RECORD OF DECISION AMENDMENT

ANACONDA REGIONAL WATER, WASTE, AND SOILS OPERABLE UNIT

Anaconda Smelter National Priorities List Site
Anaconda – Deer Lodge County, Montana

September 2011

Figure 7-1. Old Works/Stucky Ridge Subarea Significant Changes
Anaconda Regional Water, Waste, & Soils OU
Anaconda Smelter NPL Site, Montana

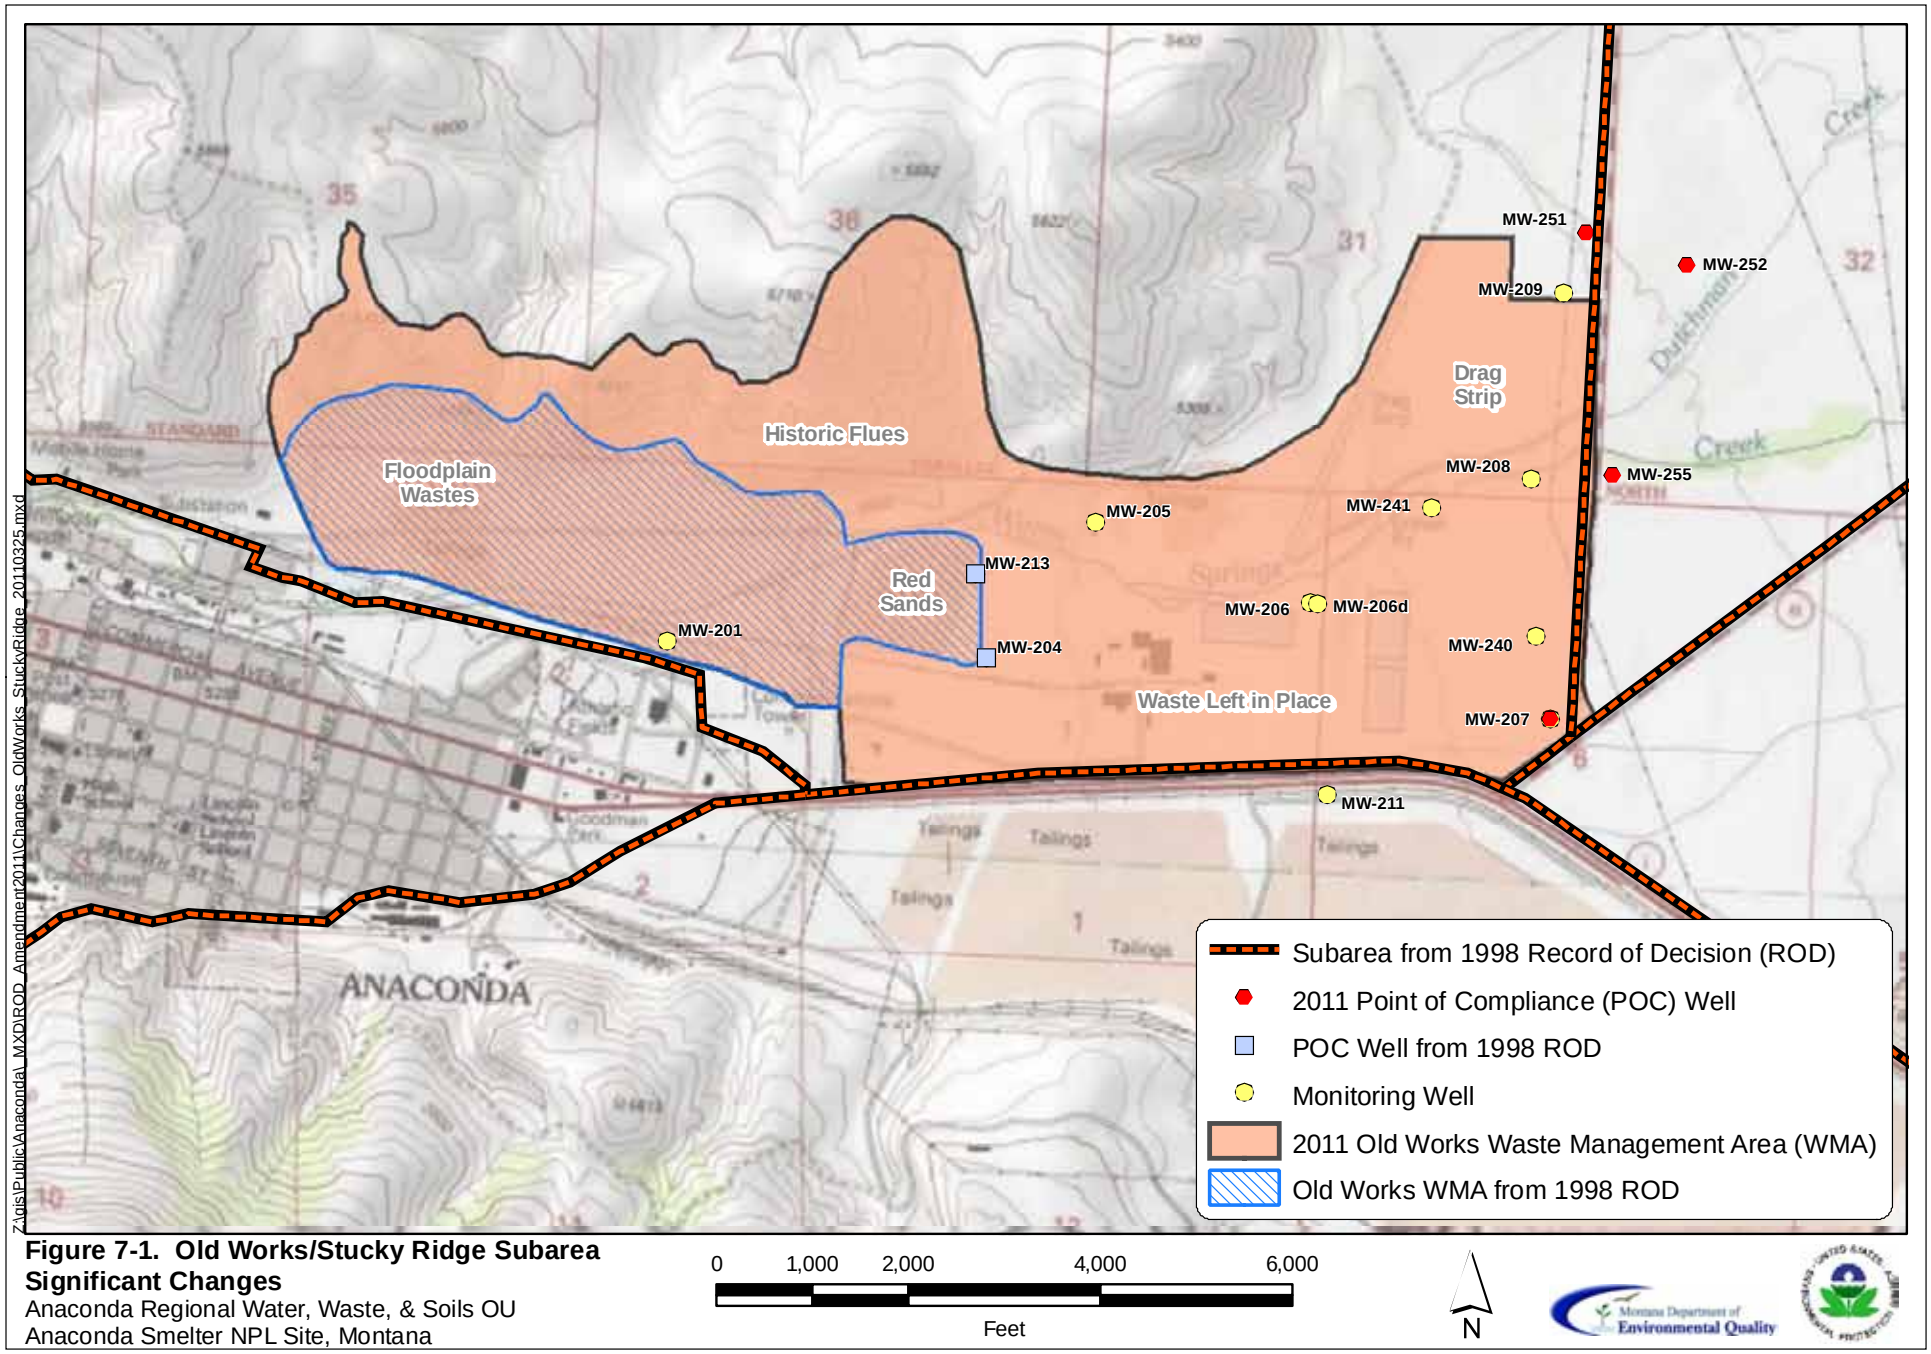
Expansion of Old Works WMA boundary requires moving the ground water POCs. Old Works ground water POCs are shown on Figure 7-1. The new POC consist of monitoring wells MW-207, MW-252, MW-251, and MW-255. The *RDU 13 Old Works Final Design Report* (Atlantic Richfield 2010) also includes a monitoring plan to monitor ground water at the POCs and within the WMA. Ground water will also be monitored during high ground water table conditions during spring runoff occur, which may mobilize precipitated contaminants in the vadose zone between low and high water table events.

Figure 8-1. Smelter Hill Subarea Significant Changes
Anaconda Regional Water, Waste, & Soils OU
Anaconda Smelter NPL Site, Montana

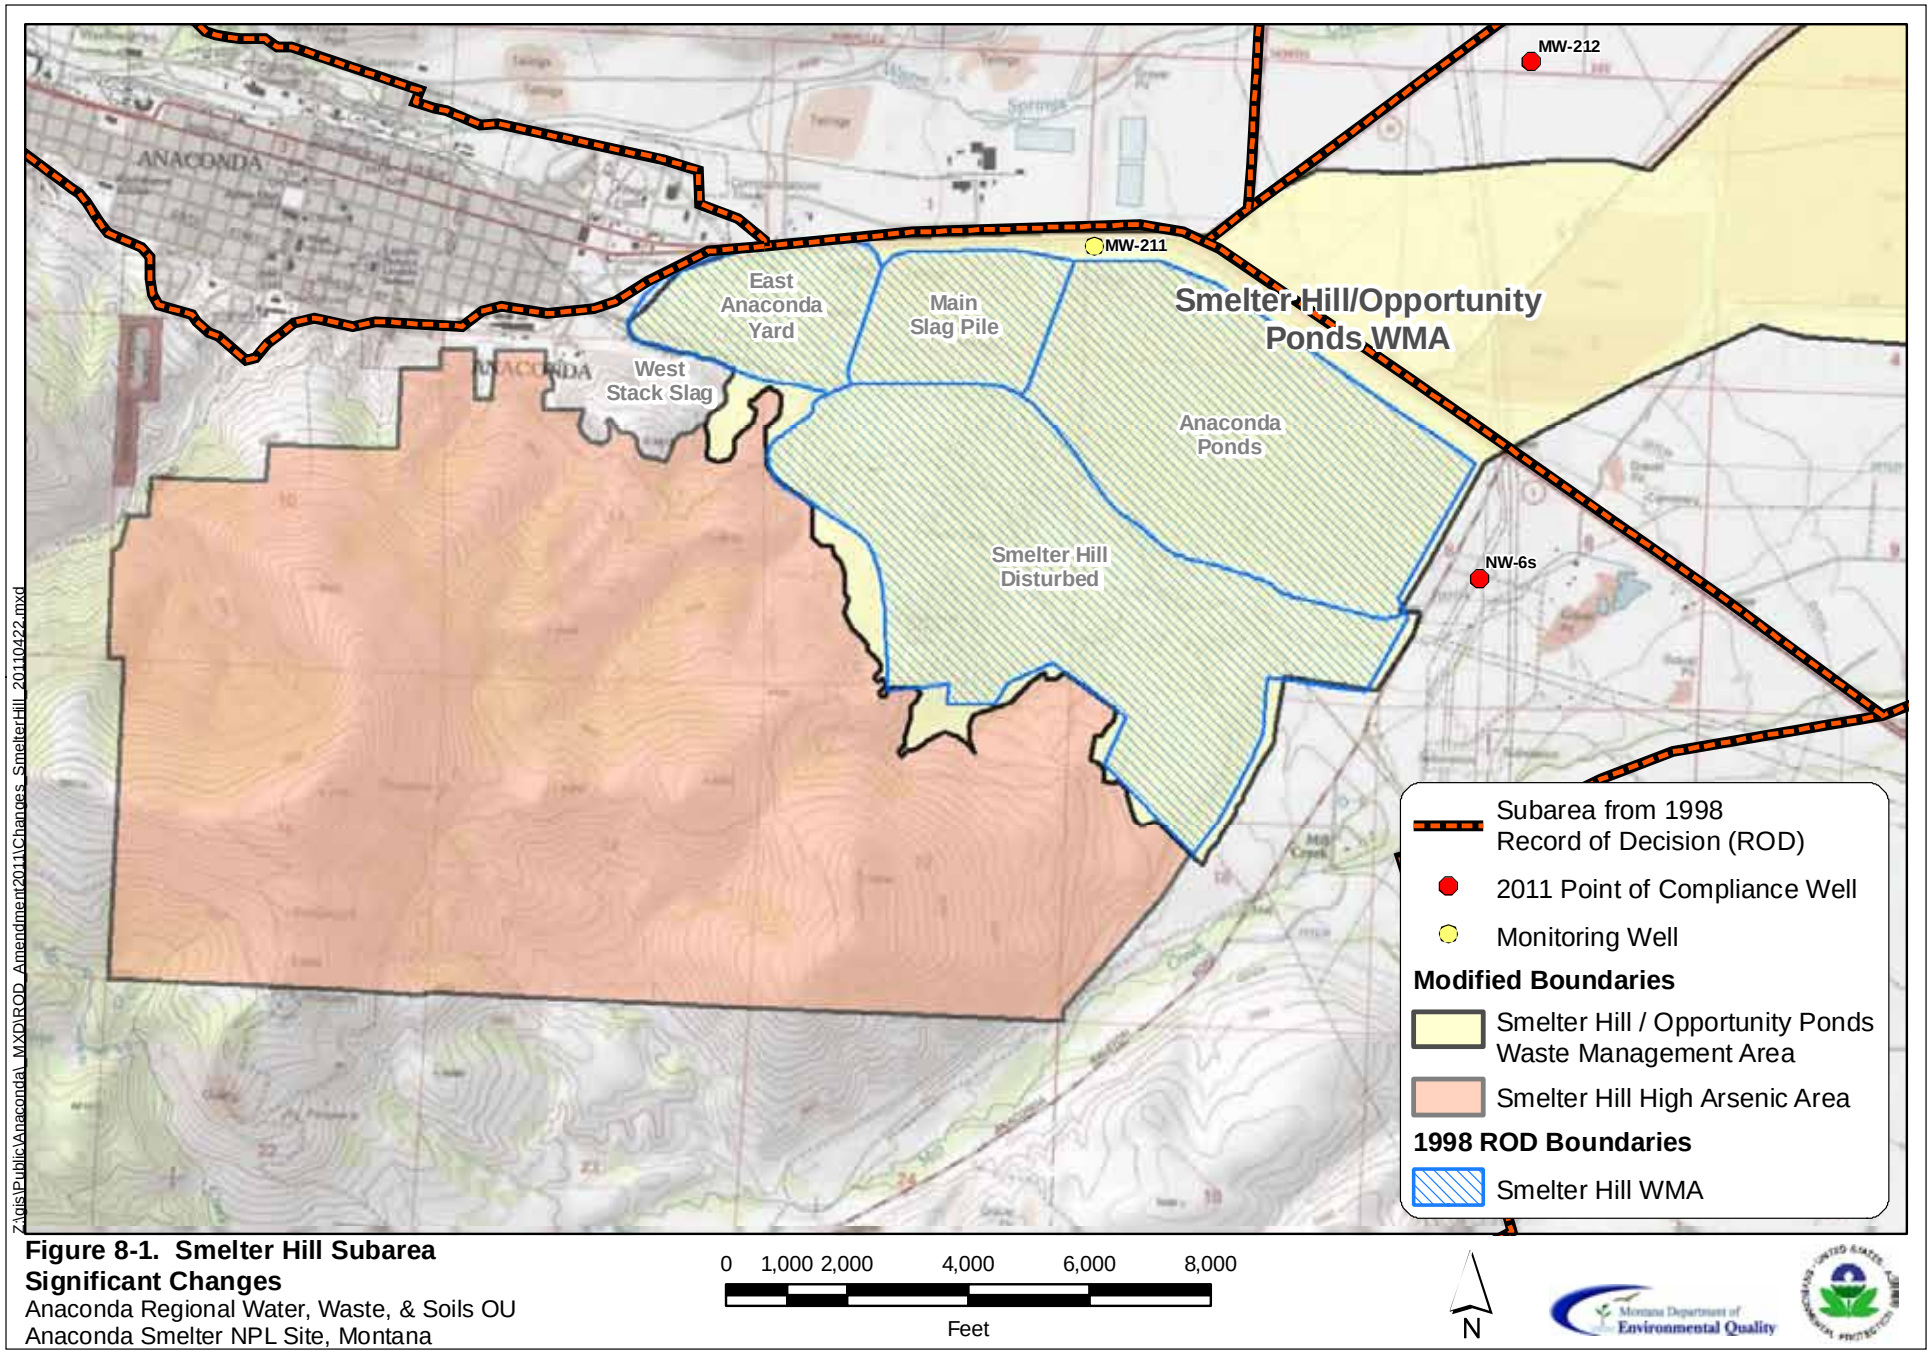
As discussed in Section 3.3, waste management area boundaries have been expanded to include adjacent waste-left-in-place areas which will simplify future management of wastes. EPA and DEQ have expanded the Smelter Hill WMA boundary to include wastes associated with the Anaconda Smelter Handling, Processing and Storage Areas and the West Stack Slag. The modified WMA boundary is shown in the Final Smelter Hill Facilities RAWP/FDR and Figure 8-1.

With the expansion of the Opportunity Ponds WMA to include the Triangle Wastes Area as discussed in Sections 1.1, 3.3, 3.4, and 4.1, the two WMAs are merged into one WMA, referred to as the Smelter Hill/Opportunity Ponds WMA. The revised Smelter Hill WMA boundary is shown on Figure 8-1. Because the Opportunity Ponds and Smelter Hill WMAs have been merged, previous ground water POCs identified at the toe of the Anaconda Ponds in the 1998 ROD are withdrawn. A new POC at the flank of the Anaconda Ponds (NW- 6s) is identified under this ROD Amendment, as shown in Figure 8-1.

The Smelter Hill HAA is shown in Figure 8-1. This area is located in a restricted access uplands area on property owned by Atlantic Richfield and Anaconda-Deer Lodge County. As noted on page DS-74 of the 1998 ARWW&S OU ROD, EPA and DEQ have determined that certain areas exceeding 1,000 mg/kg arsenic, consisting mainly of steep slope areas where it would be impracticable to use conventional reclamation techniques may have an action level of 2,500 mg/kg arsenic, and remain protective of

human health and wildlife in these restricted access areas. This ROD Amendment incorporates the Smelter Hill HAA as shown in Figure 8-1 as part of the remedy.

Figure 9-1. Bedrock Aquifer/Spring-Fed Tributaries Fundamental Changes

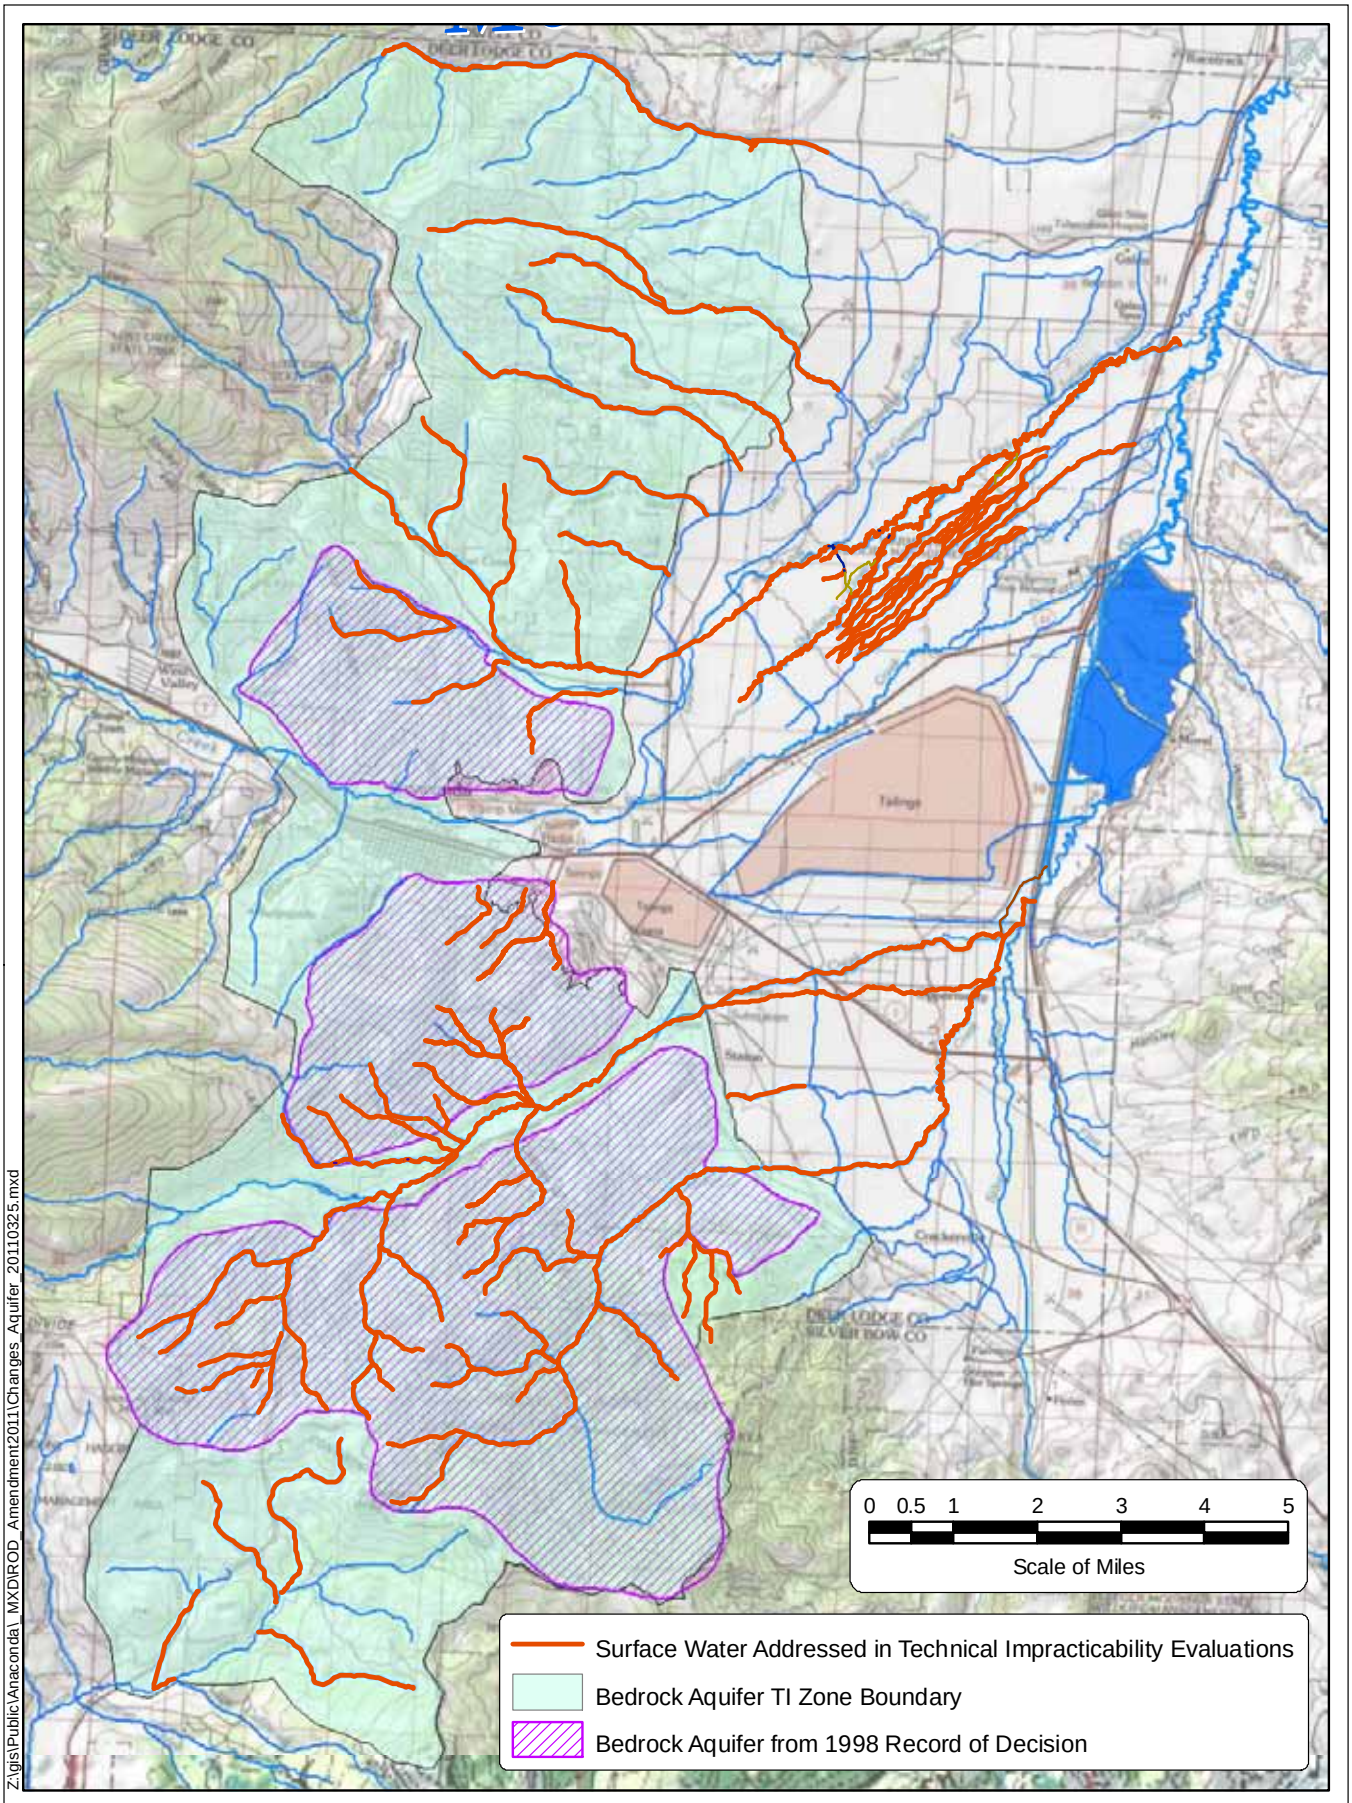
Based on the additional information presented in the second addendum to the bedrock TI evaluation, the TI zone boundaries are revised as shown in Figure 9-1. Areas where ground water in the bedrock aquifer exceeds the standard of 10 µg/L arsenic are delineated based on direct ground water sampling in wells and springs. While the previous bedrock TI Zone delineations relied on this direct sampling data, this addendum also incorporates surface water data collected from spring-fed tributaries as a surrogate for ground water data. Surface water data collected from tributaries is indicative of ground water quality (due to discharge from springs) and ground water contamination is inferred based on surface water quality. Ground water in the bedrock aquifer beneath alluvium in the Warm Springs Creek valley is known to be contaminated and it is assumed that the bedrock aquifer beneath other alluvial valleys is also contaminated.

The Spring-Fed Tributaries TI Analysis focuses on the spring-fed tributaries to mainstem named streams because the available data are mostly limited to these water bodies. Figure 9-1 shows the surface waters addressed in the TI Analyses. The results of the analysis are extended to include all state surface water within the boundaries of the TI Zone shown in Figure 9-1 because the loading sources are continuous and the potential exists for arsenic concentrations to occasionally exceed 10 μg/L in surface water throughout the TI Zone.
